ADDENDUM No. 3

PROJECT: I-85 North Bridge
 Project No.: 512-15-003
 Bid Number: HC2020-2040

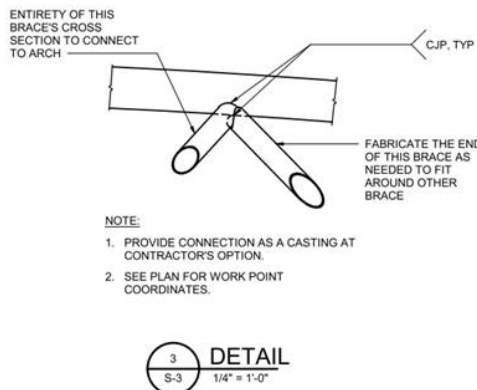
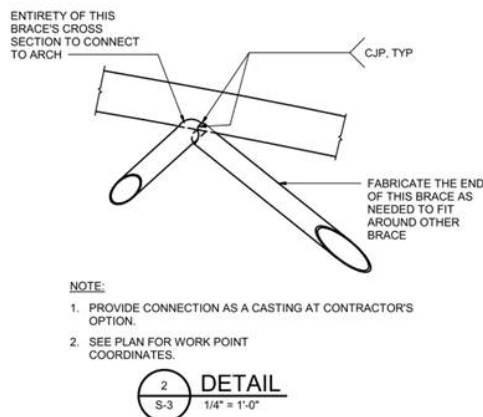
1. Please confirm what details can be provided for the following. The key issues with the details below are :
 - a) There is no joints and segment length specified for 79.2m span arch girders, therefore no detail connections for required joints
 - b) The connection between Bracings to main arch girder is shop welding, this makes the parts too hard to be shipped
 - c) No specific corrosion protective coating specified.
 Connection joint of one main arch to the other main arch:

Connection joints for pipe bracings to main arches:

Answer: See respective answers below:

- a) Correct splice locations are not specified. The number and locations of splices are deferred to the fabricator and erector. Per NOTE: B and C/S-2 "Splices are to develop full axial, shear, and moment capacities of the section."
- b) Our thought was that those connections would be shop welded and splices made away from the connection members due to the geometry of the connections. Those welds can be field constructed if preferred by the fabricator and erector.
- c) Painting shall be in accordance with Section 442 Painting Steel Structures of the NCDOT 2018 Standard Specifications for Roads and Structures.
